**Re:** Framing Item  
Lot 21 Atherstone – 123 Taverners Lane (Angier, NC 27501)

The client referenced above requests **Queen City Consulting and Design, PLLC** to evaluate framing items at the address referenced above. The structural plans were provided by Queen City Consulting and Design, and sealed by Christopher T. Blackwell on January 20, 2024. All orientations in the report reference directions as if the reader is viewing the front of the house from the street.

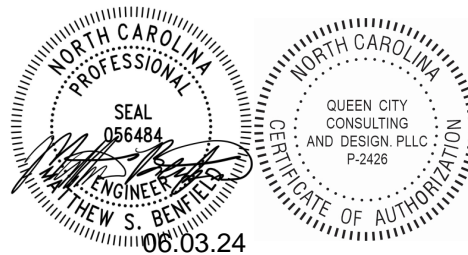
Contractor has installed the front to back stair header shifted approximately 3.5" towards the rear of the home.

Based on our review, the contractor shall install (2) full height studs under the front end of the installed front to back stair header to adequately support the anticipated loading conditions.
